**Re: Pilot Test Work Plan for Groundwater Extraction and Treatment – HW-1 Well
NYSDEC Site Name: Olin Corporation – Chemicals Group
NYSDEC Site No – 828018A
100 McKee Road, Rochester, Monroe County, New York, 14611**

Subject: Revision 2 - Pilot Test Work Plan for Groundwater Extraction and Treatment - HW-1 Well, Arch Chemicals (Site #828018a) 100 McKee Rd., Rochester, NY

Subject: Revision 2 - Pilot Test Work Plan for Groundwater Extraction and Treatment - HW-1 Well, Arch Chemicals Inc., 100 McKee Road, Rochester NY

Attachment 1
Response to comments to March 22, 2023 NYSDEC comment letter

Figure 2- HW-1 Layout and Pilot Test Monitoring Network

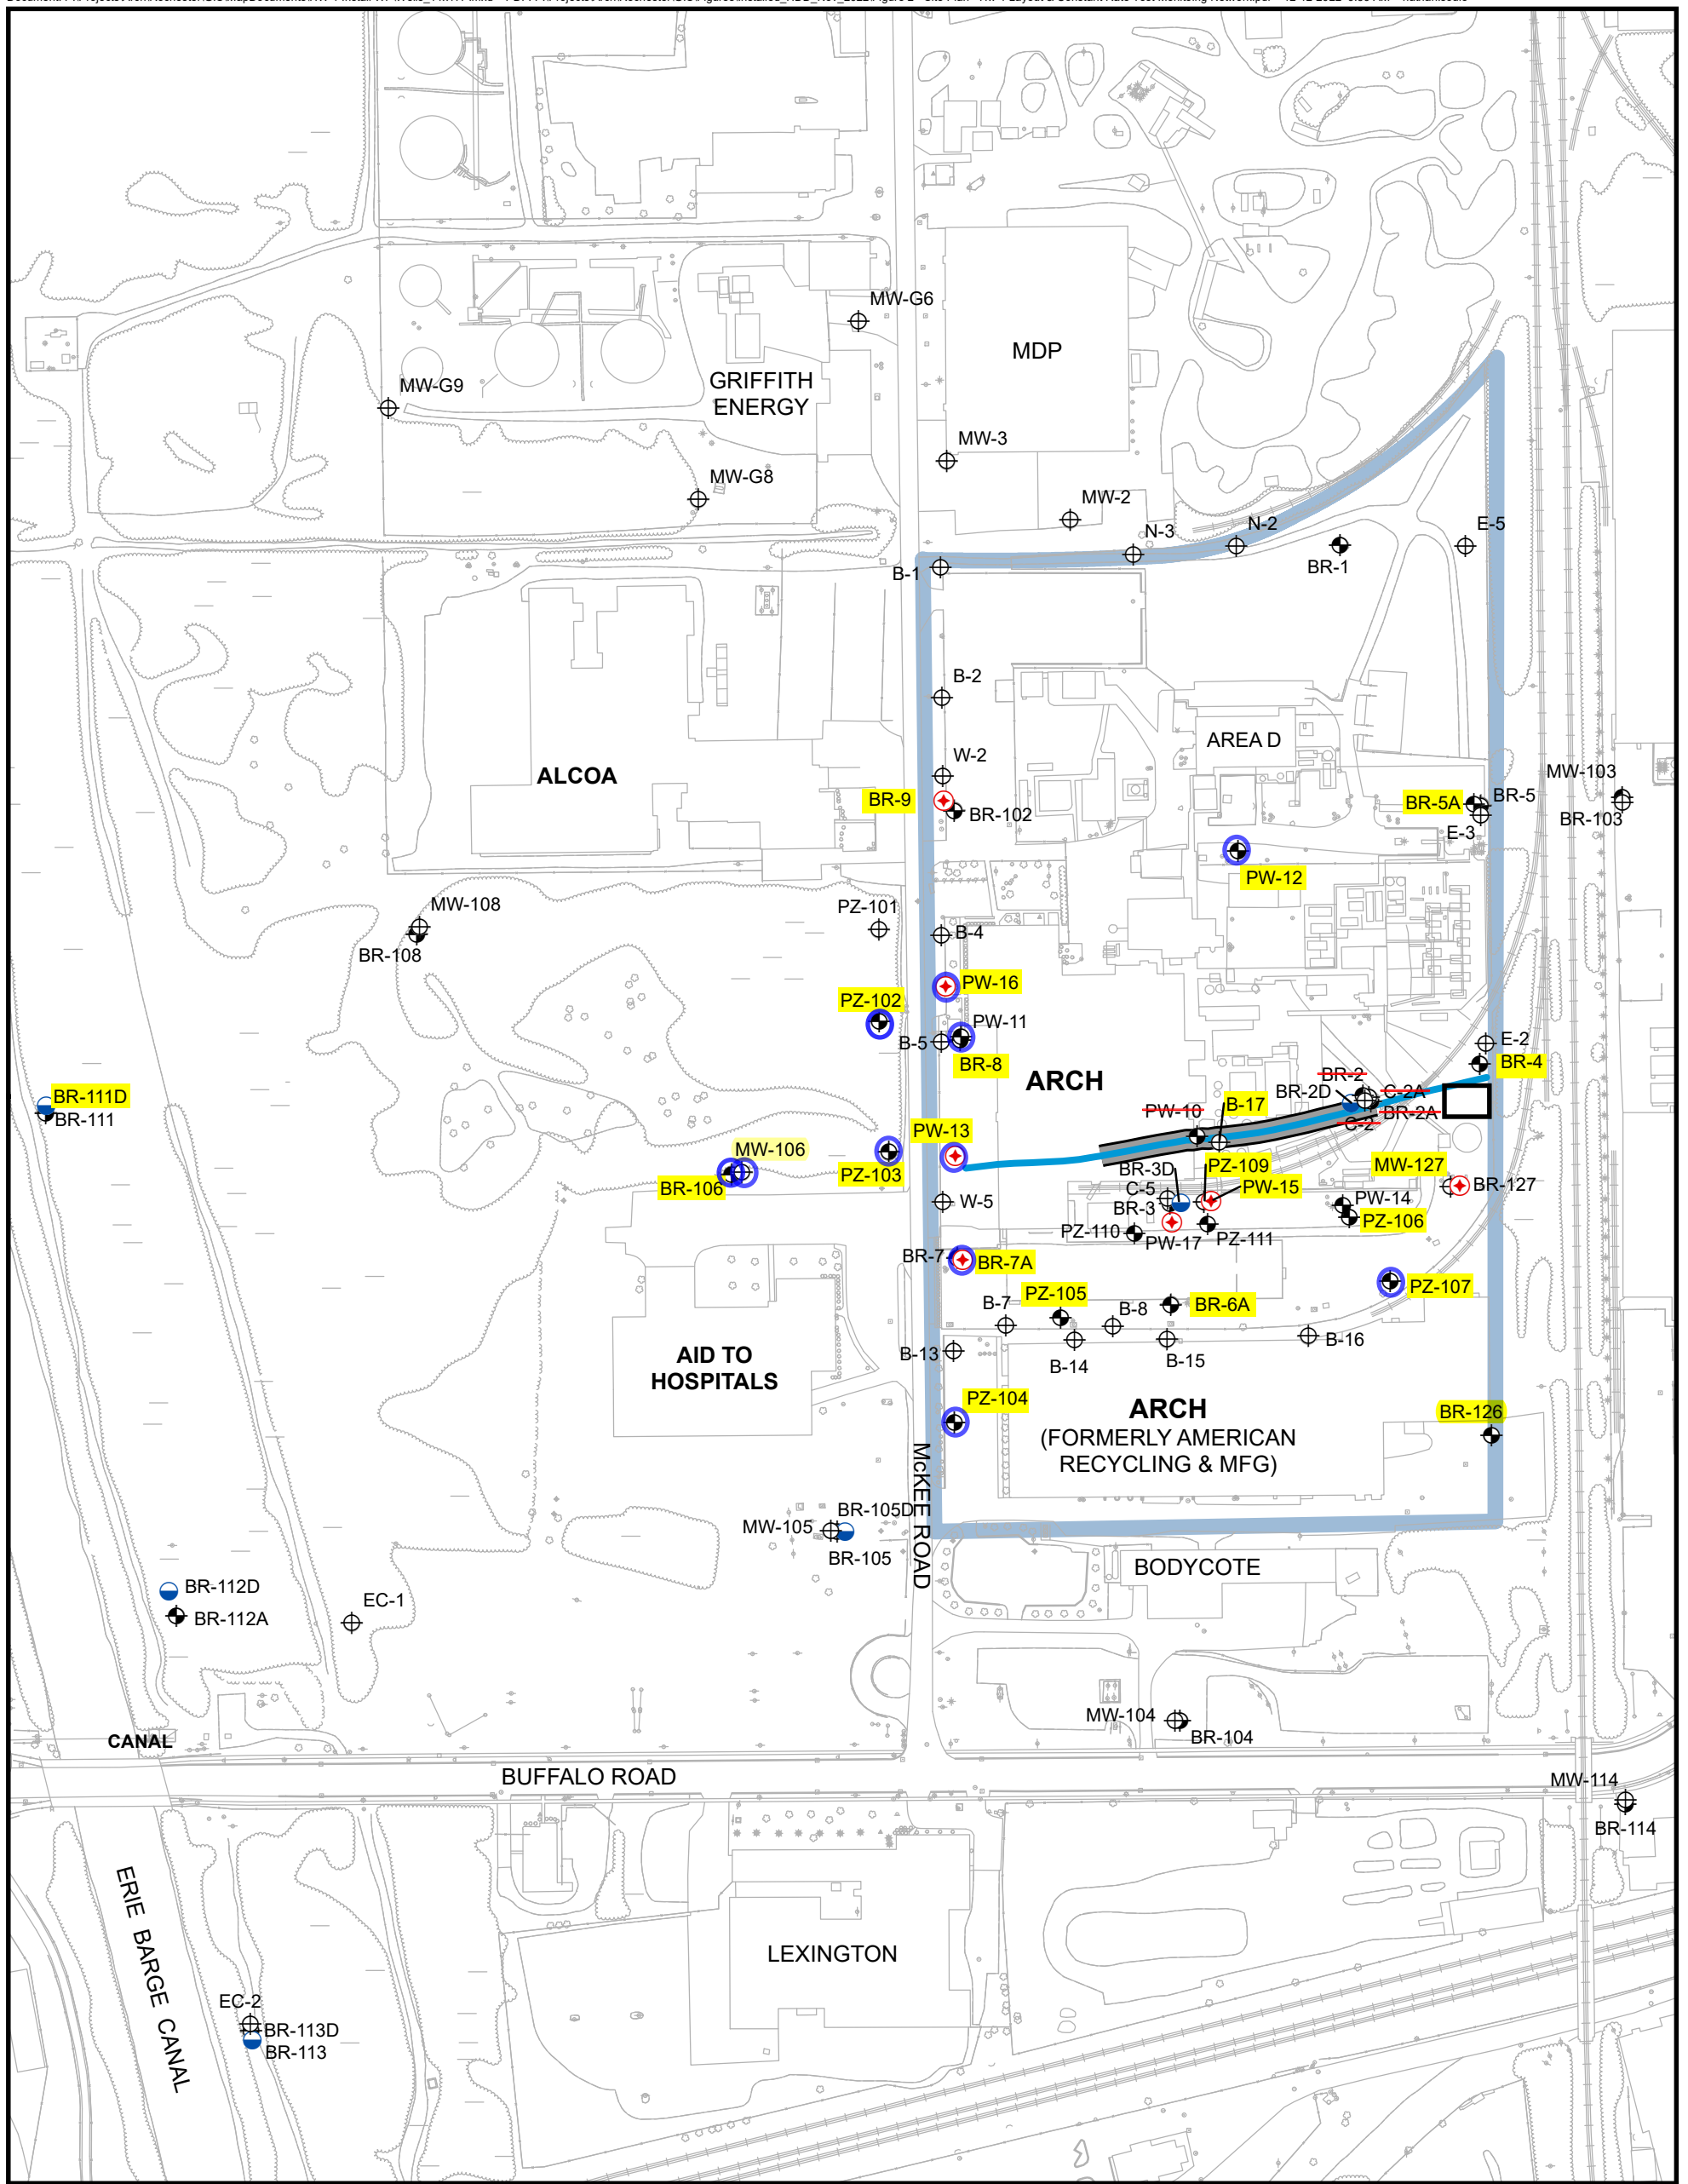
1. The Departments would like to see the following well to be added to the monthly sampling program to better understand the efficiency of the extraction well.

a. PW-12

2. The Departments would like to see the following well to be added to the monthly gauging program to better understand the drawdown of the extraction well.

a. BR-126

Response: *PW-12 has been added to the monthly sampling program.*

Response: *BR-126 will be added to the weekly gauging program. The current gauging schedule is planned as weekly event for a 2-month period. However, Arch may seek NYSDEC approval to reduce the gauging frequency if the pilot test extends beyond two months.*

Appendix 2 - Sketch Map Treatment and Discharge Locations

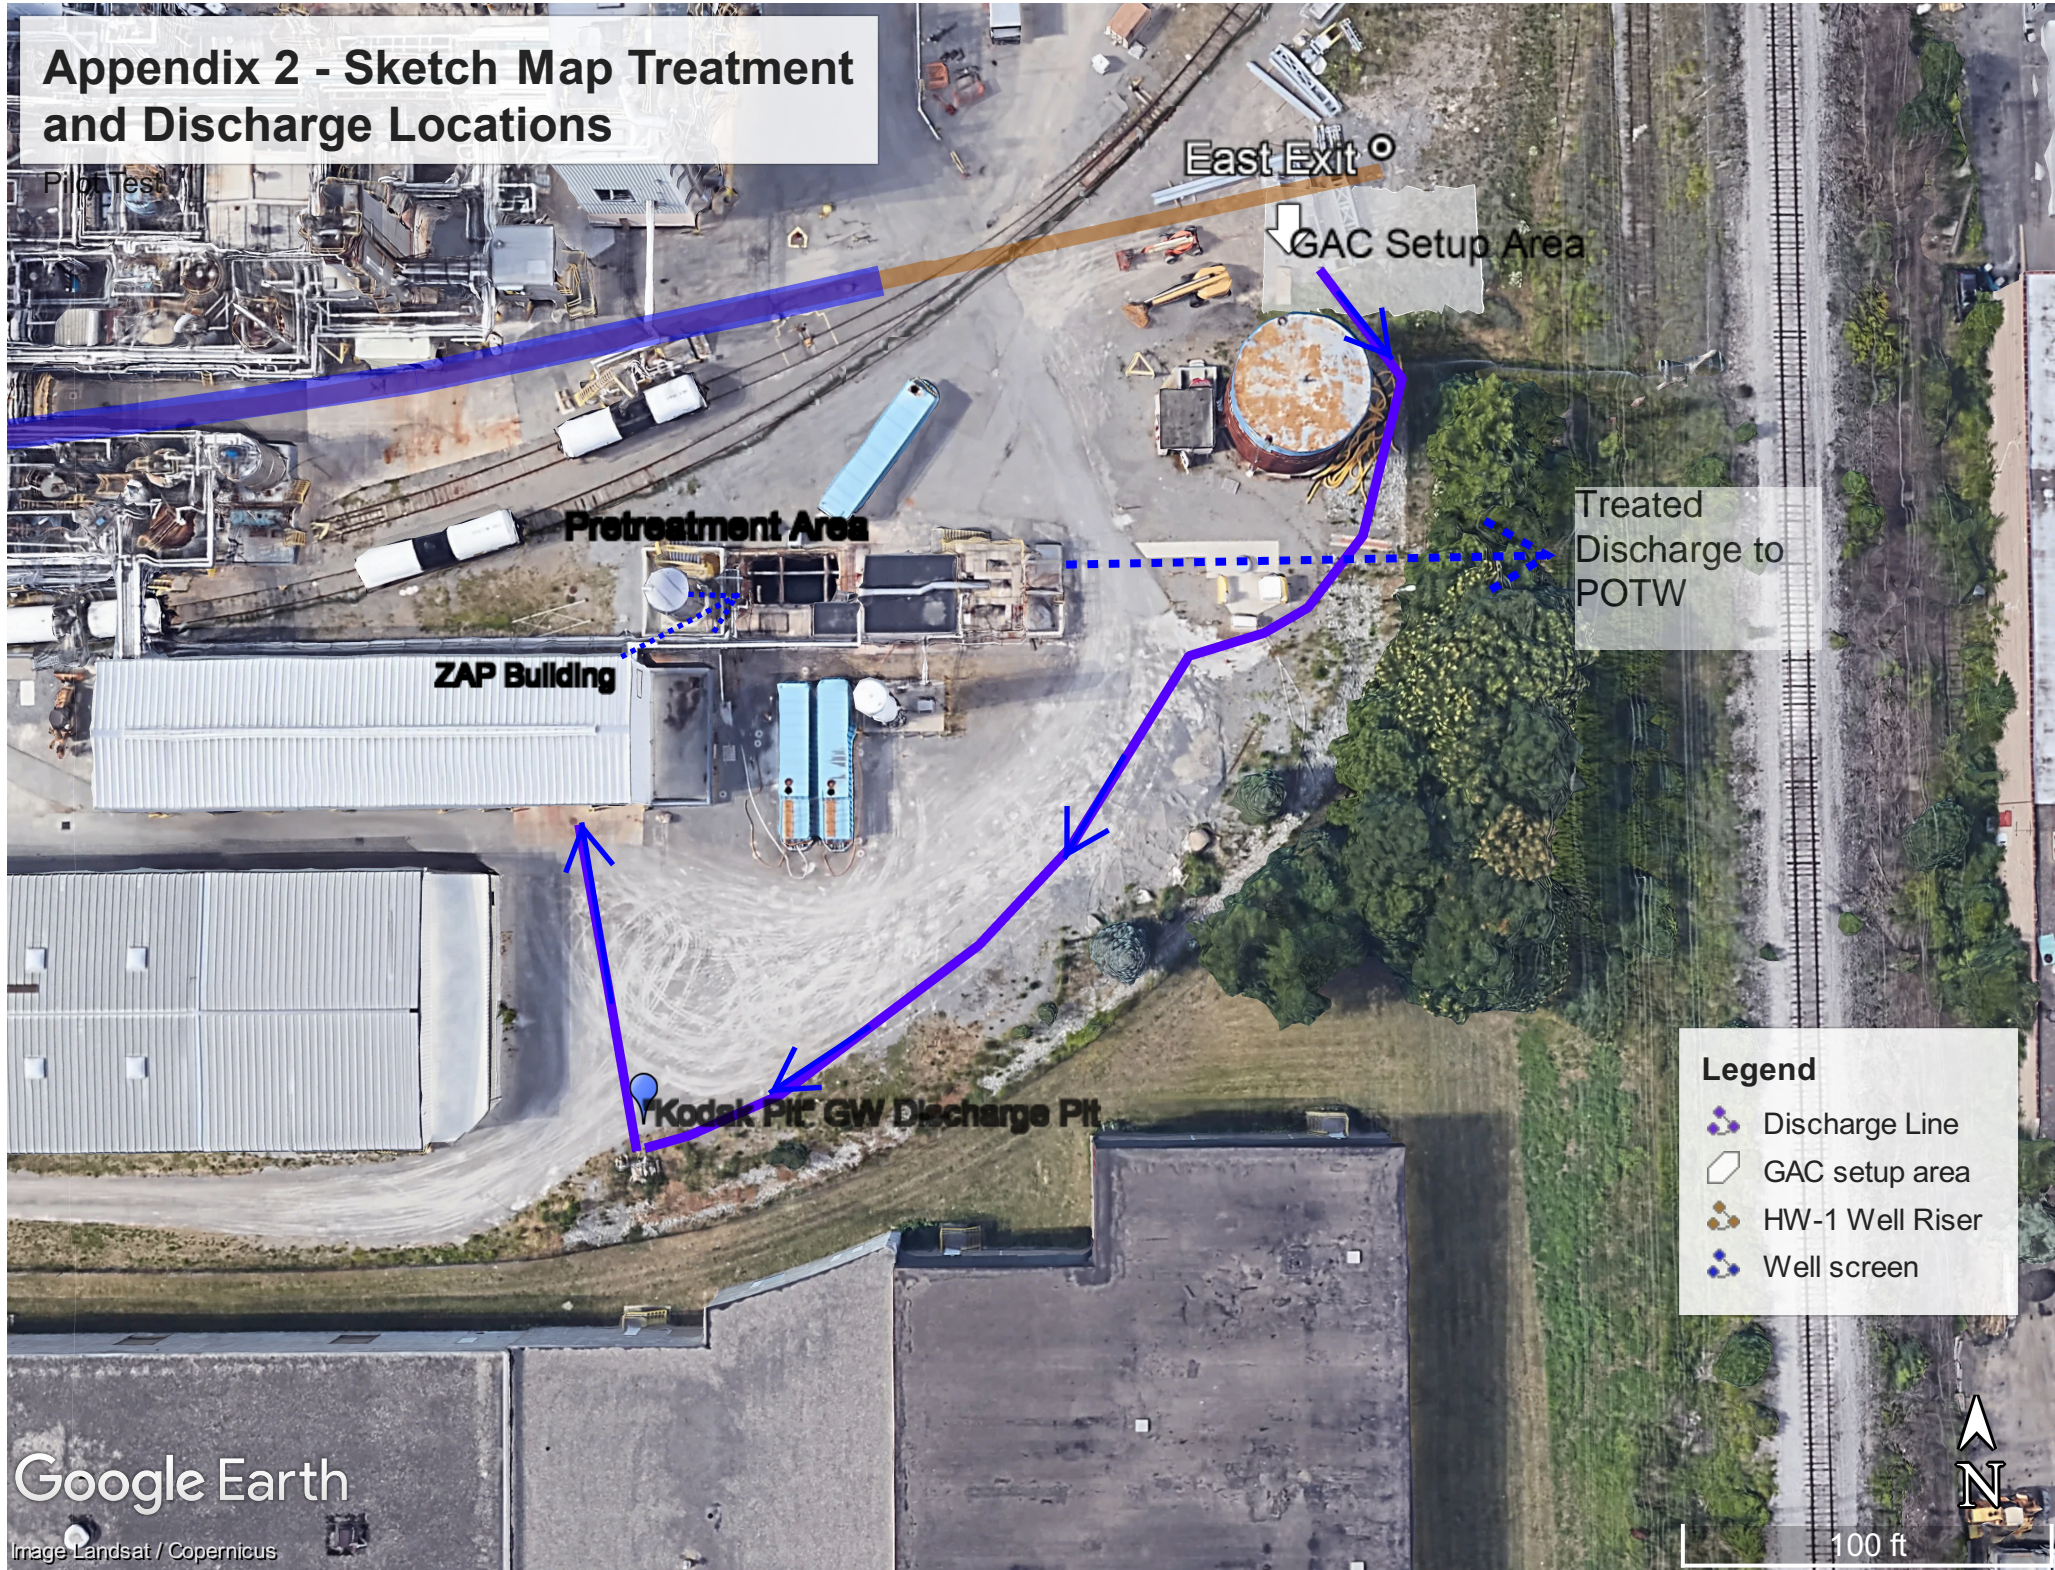
10. Please expand on the process the water will go through after it is extracted from the well and include more information on the collection “kodak” pit system and the ZAP building/pre-treatment area. Is the pit lined?

Response: *The “kodak” pit is cited in the work plan as the same pit that currently receives untreated groundwater discharge from the six operating wells. This is a concrete lined pit that receives discharge from these extraction wells at a rate greater than that planned for the pilot test. Groundwater will be transferred from this pit -to the ZAP Building where groundwater effluent is currently received through underground piping from the kodak pit. The ZAP building is the location of GAC units that currently handle groundwater discharge from the six operating wells. Since these six wells will not be in operation during the pilot test, water may be transferred to the GAC units in the ZAP building should the need arise to divert effluent for additional treatment. No changes to the work plan are proposed.*
